SUNDRY NOTICES AND REPORTS ON WELLS	-0 Hobbs
Do not use this form for proposals to drill or to re-enter an

Mescalero Ridge Unit #26-3 WIW

Conditions of Approval

Linn Operating Incorporated Mescalero Ridge Unit - 263 API 30-025-21857 T19S-R34E, Sec 26

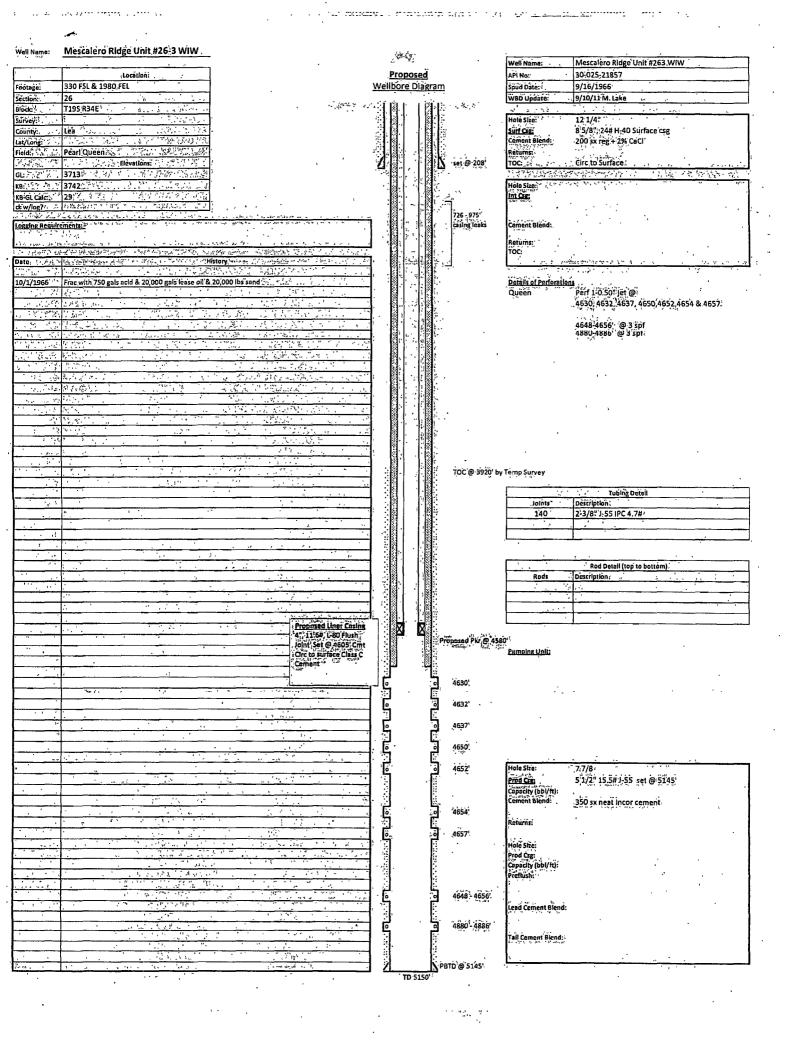
- 3. This activity is subject to like approval by the New Mexico Oil Conservation Division. -
- 4. Provide BLM with an electronic copy (Adobe Acrobat Document) cement bond log record of the proposed 4" casing from 4550' or below to top of cement. The CBL may be attached in an e-mail to pswartz@blm.gov.

- 10. Operator shall WOC for a minimum of 18 hours. Operator will perform a CIT as required in Onshore Order 2 prior to drilling out shoe of 4 casing.

- 11. When the well is plugged, operator will be required to place plugs at the Top of the Salt and in the 5-1/2" by 8-5/8" annulus across the surface casing shoe and from a minimum of 60' to surface. These plugs are in addition to the normally required plugs.
- 12. Workover approval is good for 90 days (completion to be within 90 days of approval). A detailed justification is necessary for an extension.
